**Safety** Minutes of RSC Subgroup Meeting of March 13, 2014

**Subject: Review of ERL Dump Prints**

Figure: Plan view of shield and dump area, drawing 010606213.

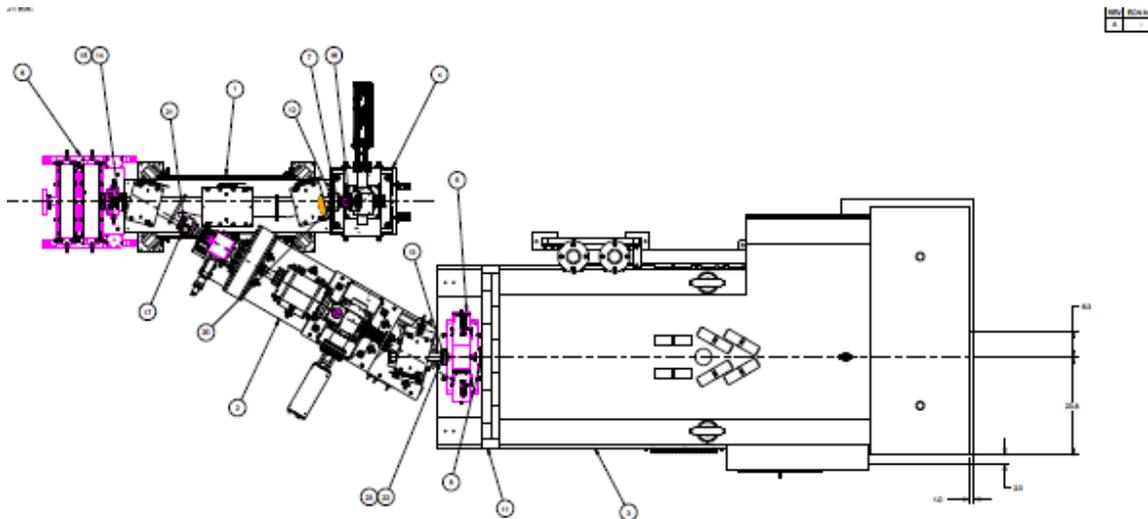
There is a steel shield between the dipole and the beam dump. The original purpose of this shield was to provide for equipment protection from the back-shine from the beam dump. However, portions of the beam dump are struck by electrons that are at the same elevation as the horizontal seams in the concrete wall. The x-ray transmission through the seams is very sensitivity to the source elevation. In addition, the analysis of interlocks and faults has not been completed for the transport at and beyond the first dipole. An incorrect set-point of the last dipole or if the magnet turns off will cause the beam will strike the Pb shield. It was decided that the Pb shield should be considered as area shielding and the prints for the Pb shield be upgraded to QA-1.

The RSC Chair noted that he is not a fan of stacking small Pb bricks to make shields and would encourage projects in the future to make such shields out of larger blocks that cannot be moved by hand. Naturally, there are economic and schedule issues associated with such construction biases. The bricks are overlapped in one dimension but not the other. This was not considered to be a problem. However, the Pb assembly will need to be banded and posted.

There are two three-inch diameter holes with associated plugs. The plug on the six-inch thick plate was recommended to be changed so that it completely fills the hole rather than the last three inches. The plugs can be made flush with the outside of the steel surface rather than a large protrusion. Tack welding the plugs in place was considered acceptable in case the ports are needed for future use.

1. Update appropriate prints to QA-1 including the Pb shielding
2. Band and post the Pb shield.
3. Archive the results of the Pb analysis
4. Modify plug and attach both
5. Finalize end shielding design
6. Determine configuration past first dump dipole and analyze.

**Figure: Side view of beam dump end and cast ion B block, drawing 010606213.**

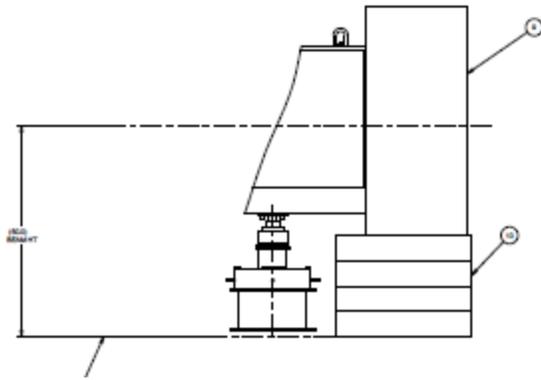
The project would like to change the design of the end steel. A cast-iron B block will be centered about the beam dump in both vertical and horizontal directions. This will eliminate in the shield materials near beam height. The final design needs to consider whether the cast-iron B block needs shielding on top. It was noted that the block serves to shadow the labyrinth wall from both losses in the beam lines and from the radiation generated in the beam dump.
